Subject: Chinook ZD576 Accident on the Mull of Kintyre – Evidence before the House of Lords Select Committee: Request for Boeing Review and Re-simulation.

Reference: Chinook HC Mk2/2A/3 – Contract CON1B/1281 – PDS Task 07A001ES; (AIR)(PHL)/140/7/PDS/01, Dated 5 March 2002.

Enclosure 1
02-8-1130-0916 (ASI Ref. 8-7D20-DSS-0306)

Subject: Mull of Kintyre - Response of HC Mk2 Helicopter to Longitudinal and Collective Inputs

HC Mk2 Forward Climb Capability 152m (500 ft) / Standard Atmosphere

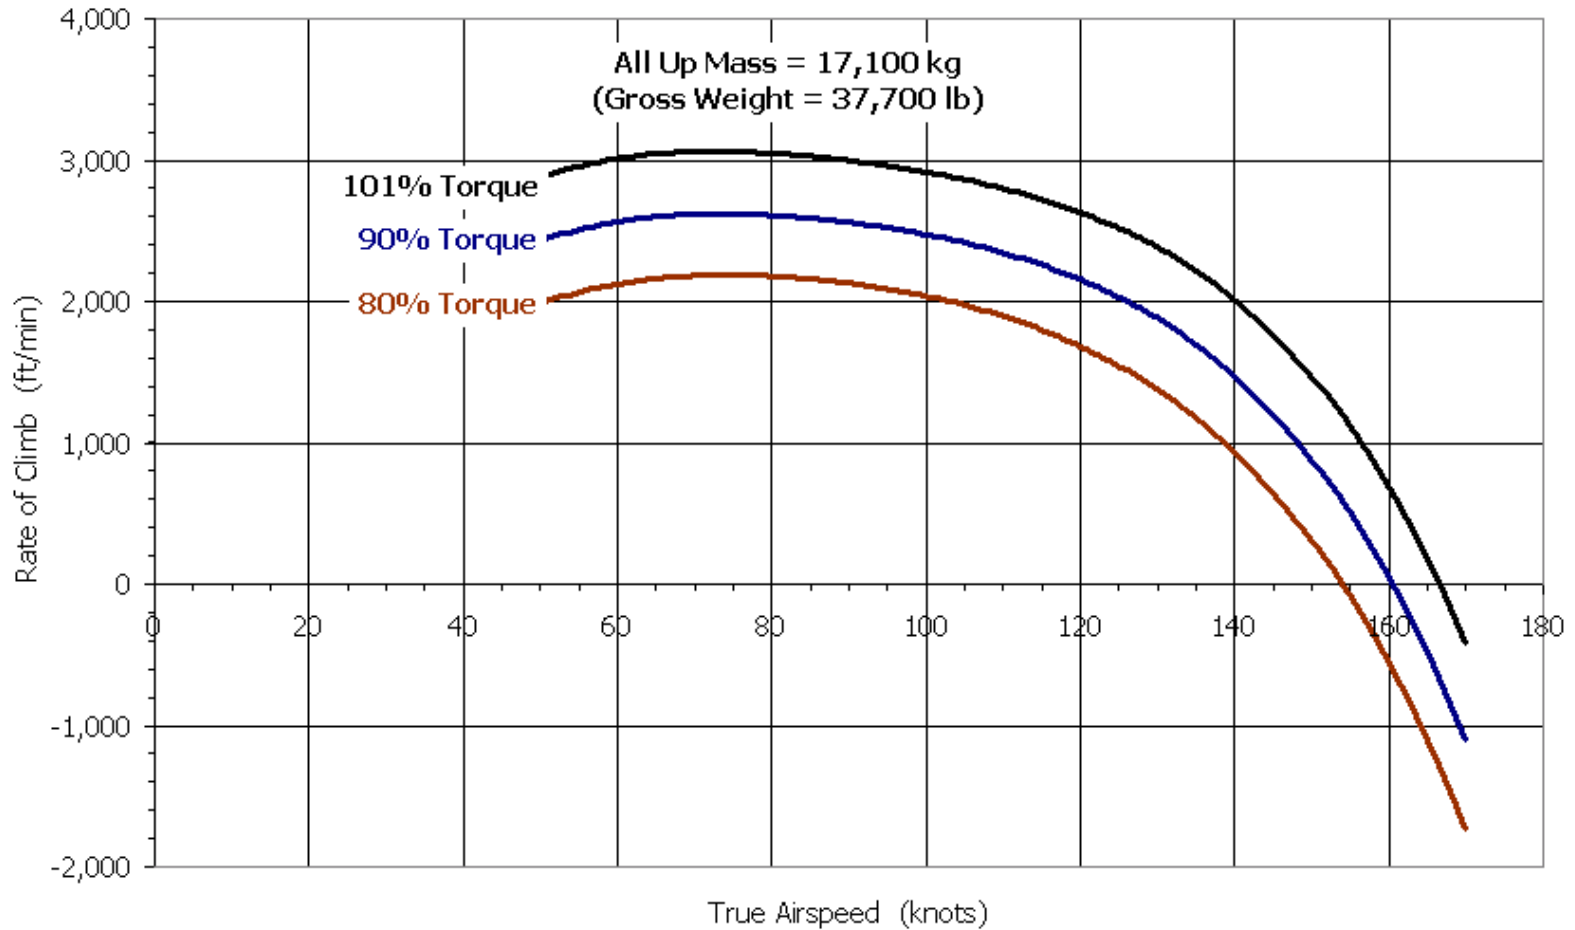
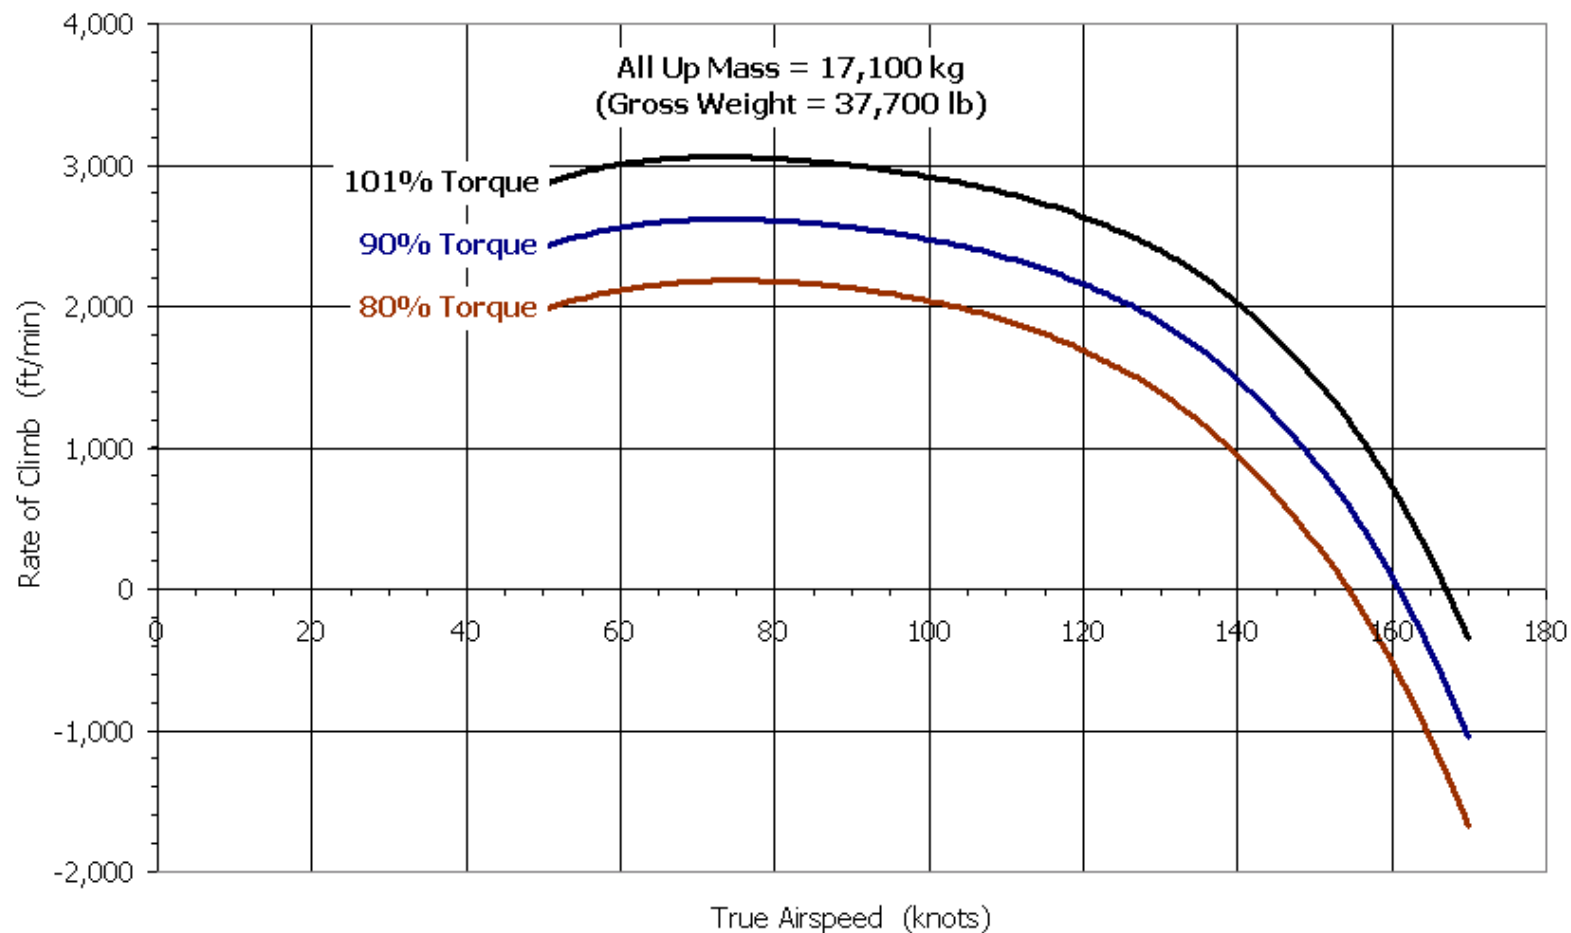
127. Sir John Day had arranged for someone to fly the Chinook simulator at 150 knots; they achieved a ROC of 650 feet per minute (Q 1075). He accepted that a ROC of 1000 feet per minute and a speed of 150 knots were not compatible (Q 1075). However, he put it to us that he had always said that the ROC was about 1000 feet per minute, not precisely that. This comment was made in the context of his own calculations, based on the range of heights shown by the TANS some 15-18 seconds before impact, which showed that between those times and the start of the final flare the range of possible ROC was between 650 and 1350 feet per minute. The simulator which produced a ROC of 650 feet per minute at 150 knots also produced one of 1150 feet per minute at 135 knots, which was a speed for which Boeing found it "very difficult or impossible" to match the predicted conditions with the initial impact data (AAIB statement para 8, QQ 1074-80).

The various references to rate of climb (ROC) vs. airspeed that the HC Mk2 supposedly cannot achieve are puzzling. Boeing Philadelphia's Aerodynamics Department, responsible for calculation and compilation of the performance data in the HC Mk2's Operators Manual have produced charts for ROC vs. Airspeed that show the following: For an HC Mk2 in the conditions that ZD576 was operating in at the time of the accident, ROC capability at 150 kts (TAS) should be approximately:

450fpm@Maximum Continuous Power (83% Torque);

1000fpm@Maximum (30 min) Power (92% Torque);

1500fpm@Drive System Limit (101% Torque);

See comment on ROC performance in 126 above.
